Product Change Notice (PCN)

PCN Number: PCN-0485137R-01

Product(s) Affected: *CPM1202 Series (CPM1202-02A-02-MST-M7-67, CPM1202-03A-02-MST-M7-67, CPM1202-04A-02-MST-M7-67, CPM1202-05A-02-MST-M7-67, CPM1202-05B-02-MST-M7-67, CPM1202-08A-02-MST-M7-67, CPM1202-02A-02-MST-M9-67, CPM1202-03A-02-MST-M9-67, CPM1202-04A-02-MST-M9-67, CPM1202-05A-02-MST-M9-67, CPM1202-05B-02-MST-M9-67, CPM1202-08A-02-MST-M9-67)*

Visual differences shown below

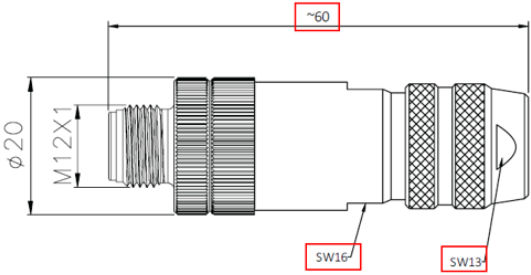
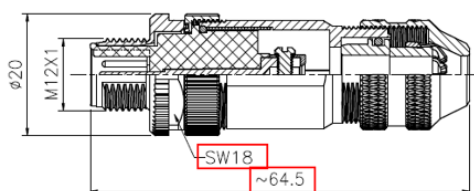
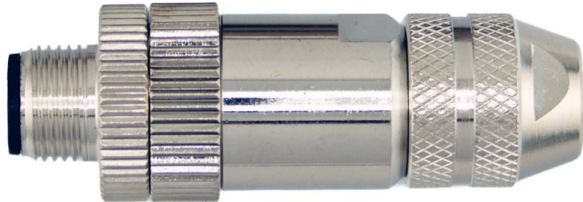
Visual differences

- Flat surface area on previously marked SW16 is now rounded
- Previously marked SW13 indentation is no longer visible on product
- Surface area on new product is now smooth
- Screw head was previously a Philips and is now a slot head
